OPEN SPACE ADVISORY BOARD

Wednesday, January 4, 2012, 1:30 P.M.

City of El Paso – City Plan Commission Staff Report

Case No: SUSU11-00120 Desert Springs Unit One
Application Type: Major Combination
CPC Hearing Date: January 5, 2012
Staff Planner: Justin Bass, (915)541-4930, bassjd@elpasotexas.gov
Location: North of Transmountain Road and East of Interstate Highway 10
Acreage: 62.89 acres
Rep District: 1
Existing Use: Vacant
Existing Zoning: A-O (Apartment-Office), C-3/c (Commercial/condition), R-3 (Residential)
Proposed Zoning: A-O (Apartment-Office), C-3/c (Commercial/condition), R-3 (Residential)

ATTACHMENT 7

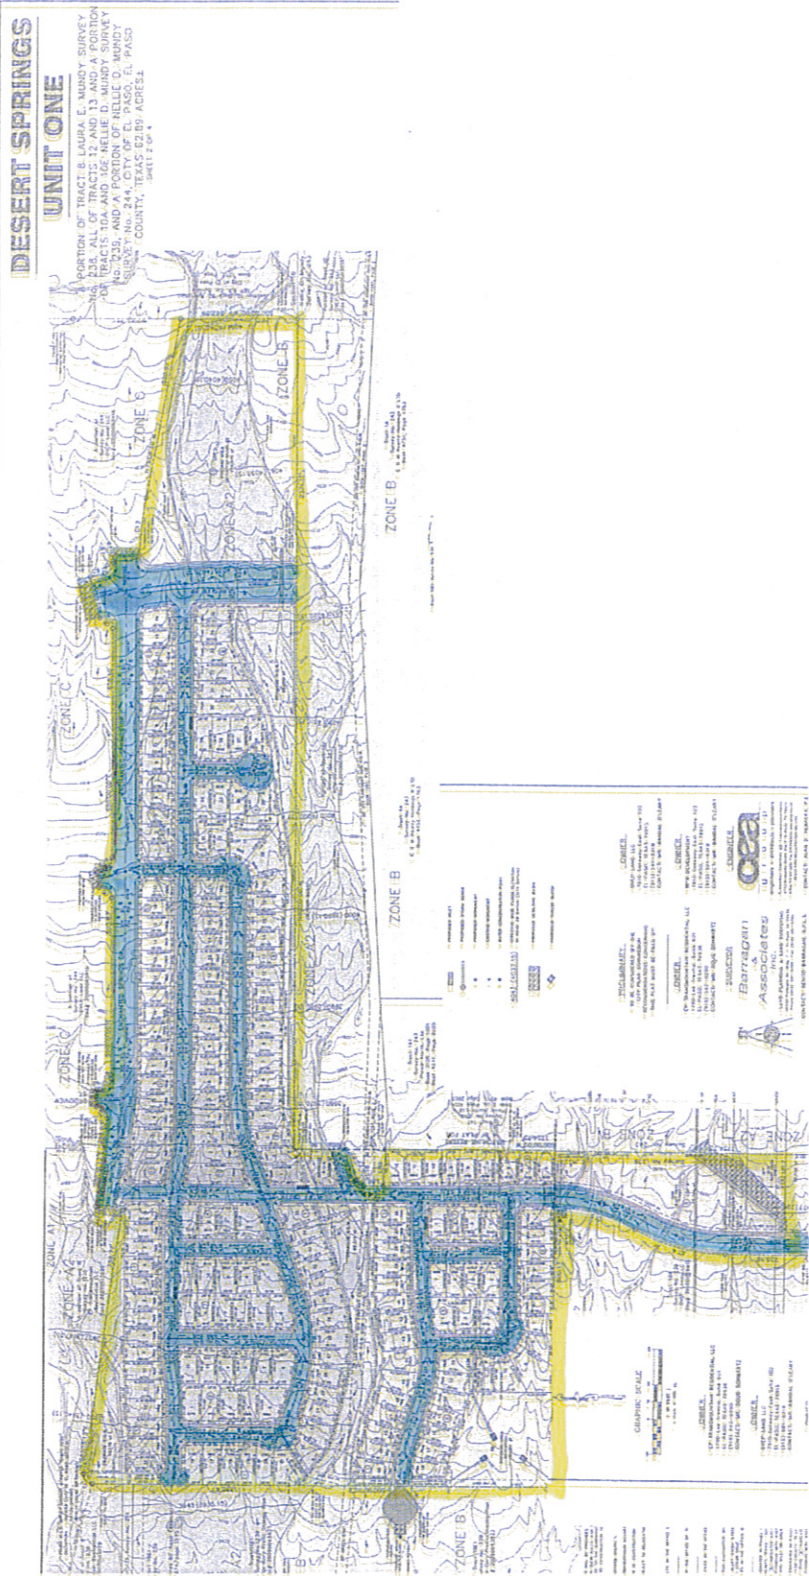
EPWU does not recommend approval of the proposed Desert Springs Unit 1 plat. The detention pond and hybrid channel designs (as shown in the Desert Springs Unit 1 subdivision improvement plans) do not meet subdivision improvement design standards. In addition, there is still a 30' Gas Company Easement located within the Drainage Right-Of-Way (see comment #6 below). EPWU objects to the channel alignment unless the gas company pipeline is relocated beneath the channel service road or outside the Drainage Right-Of-Way boundary.

1. The capacity of the proposed detention basin (Lot 1, Block 13) has increased from the previous submittal. Provide an updated request for modification to 19.16.050.H (*Stormwater Design-Preservation of Natural Arroyos*) as required by the subdivision code.

9. EPWU objects to the proposed temporary diversion dike/berm shown on the preliminary plat east of Bluff Creek Lane in Lots 1-3, Block 8. EPWU is concerned erosion and sediment deposition in this system could greatly increase culvert maintenance costs downstream. At the improvement plan stage provide an engineered structure resistant to erosion, scouring, and high water forces.
